Service Bulletin

Date: **20 November 2020**

Subject: **Fusecase cover**

Product: **Brutale 1000 Serie Oro - RR - Rush**
from vin ... LV000011 to vin ... MV000546

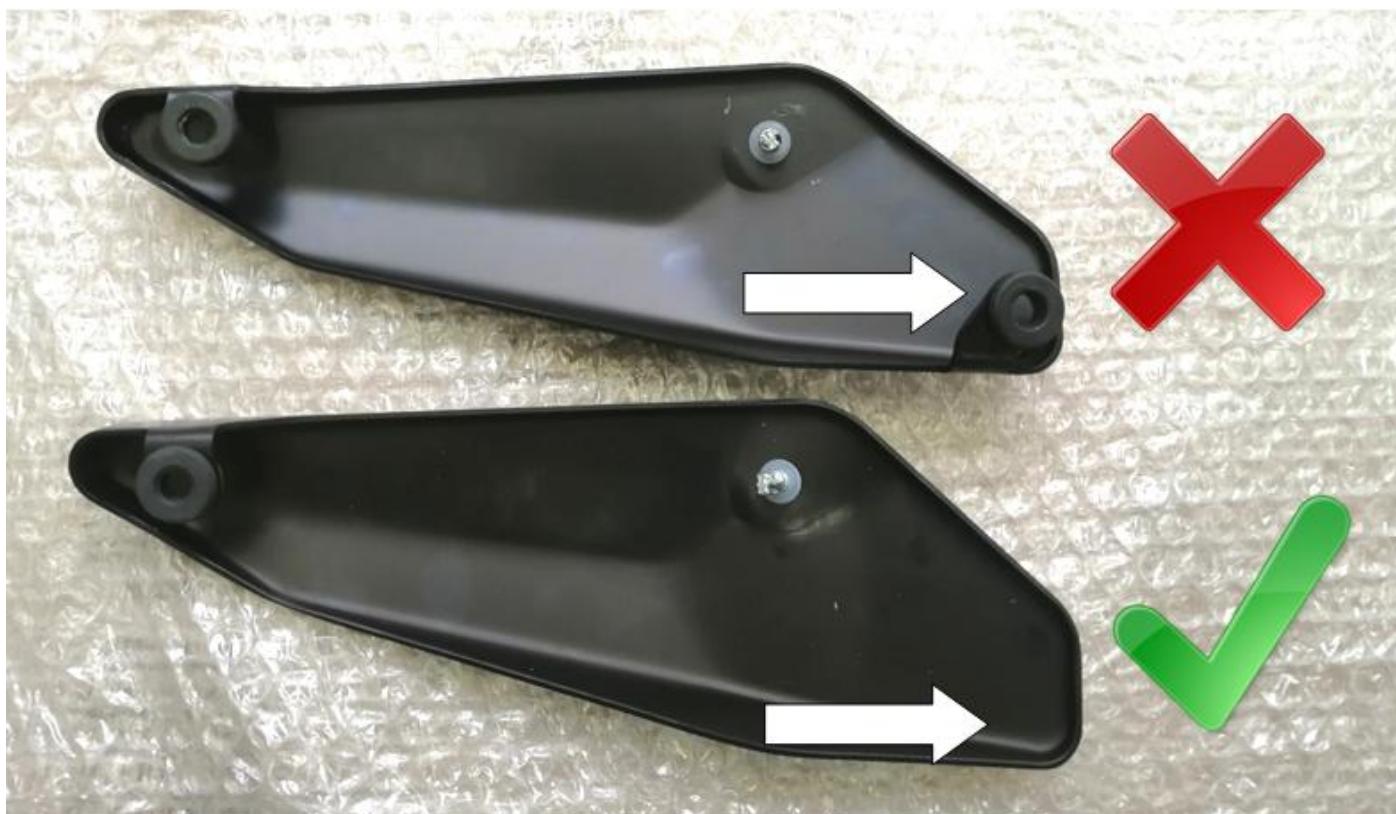
- code **8B00B4458** protective rubber pads: they must be applied to the edge of the sound-absorbing panel as shown in the figure using the layer of adhesive already present inside the surface of the rubber pads:
